DEPARTMENT OF ENVIRONMENTAL MANAGEMENT
 OFFICE OF WATER RESOURCES
 FRESHWATER WETLANDS PROGRAM
 APPROVED WITH CONDITIONS
 AS SPECIFIED IN THE LETTER OF APPROVAL
 AUG 31 2017 FILE # 17-0175
 DATED _____
 NO CHANGES ALLOWED WITHOUT PRIOR APPROVAL
 APPROVED PLANS MUST BE AT CONSTRUCTION SITE

Proposed Patio
 174 North Shore Drive
 A.P. 93, Lot 31
 Burrillville, RI

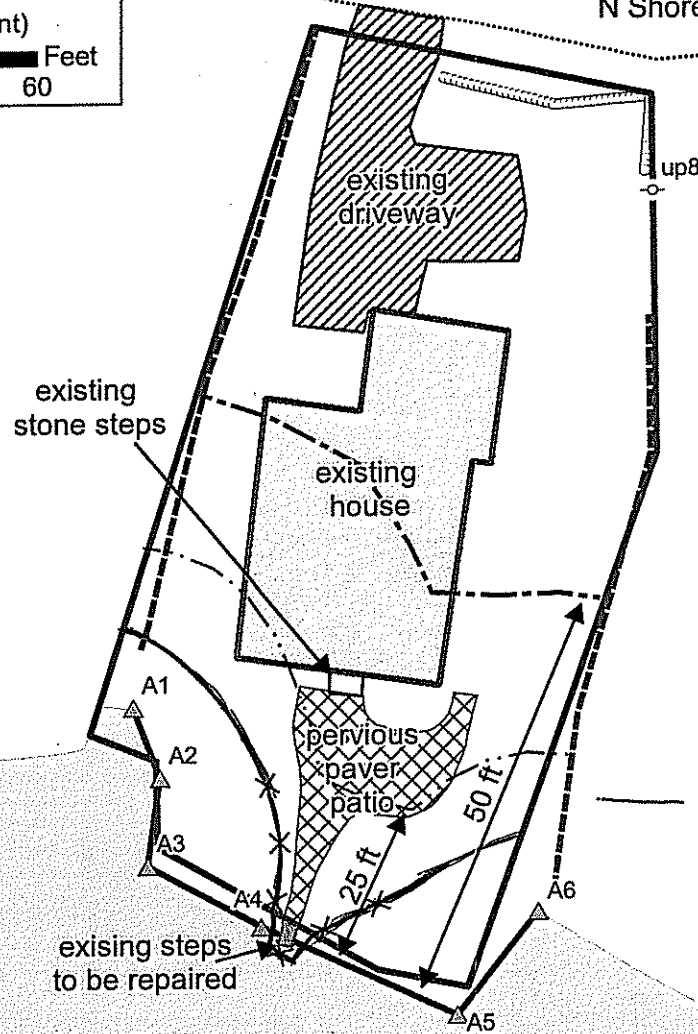
JUL 26 2017
Charles A. Haber
 = Approved Limit of Disturbance per RIDEM.
